CONTRACTOR COMPANY TRADE NAME : WSP											
CONTRACTOR REF. No. SZC-AD0252-WSP-ADHHPV-54XXXX-DRW-HCH-000006											
CONTRACT NUMBER : WSP_AD02xx_061											
CONTRACTOR WBS CODE: AD0252	QRA RELATED Yes <input type="checkbox"/> No <input checked="" type="checkbox"/>										
APPLICABILITY: 1: Document related to Unit 1 2: Document related to Unit 2 9: Document that applies to buildings/systems common to Unit 1 & 2 0: Documents that relate exclusively to buildings or systems that are common to the whole site (e.g. parking, ancillary buildings...)

NUCL/RE/IEPR/UKX		SZC (doc: SZ)		0	1	2	9	X	
NUCL/RE/IEPR/UKX											
SZC (doc: SZ)											
0	1										
2	9										
X											
BUILDING 000	SYSTEM N/A										
SCALE 1:200 SIZE A1 PAGE 1/1	DESCRIPTION PROPOSED PAVEMENT & KERBING (SOUTH OF BORDER COT LANE JUNCTION) WICKHAM MARKET SCHEME SHEET 6

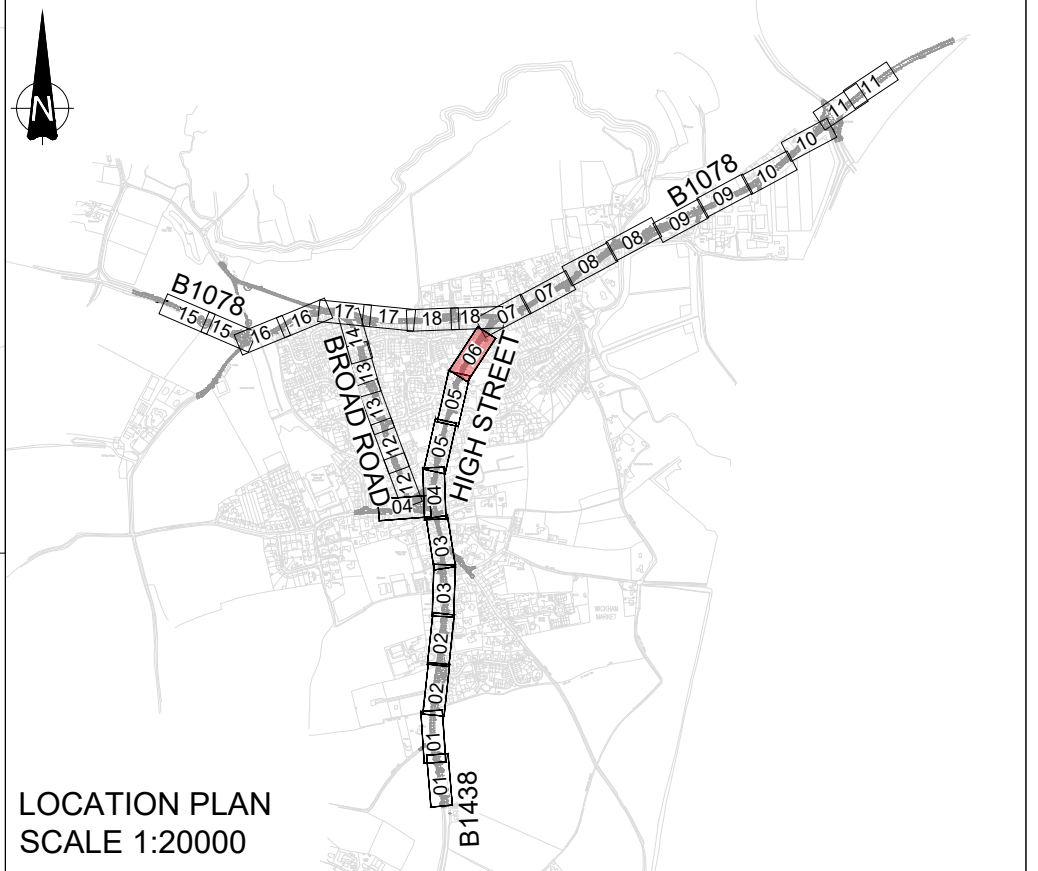
Suggestion 1
Relocate proposed build-out with give-way markings on B1438 approximately 5m south from current proposed location (towards centre of village)

Potential Compromises
Proximity to existing lay-by and the relocated gateway and buildout may cause traffic flow conflict; crossing will move away from desire line

Suggestion 2
Remove next build-out / pedestrian crossing immediately north on B1438.

Potential Compromises
Loss of traffic-calming (speed-reducing) measure, and no improvement in visibility from private access.

Removal of proposal build out will increase safety risk for pedestrians crossing the road.

By losing the build outs, pedestrian will have a longer distance to cross the road.

Benefit
Regain 2 parking space back. No net loss of existing parking spaces in this area.

Benefit
Regain 2 parking spaces back. No net loss of existing parking spaces in this area.
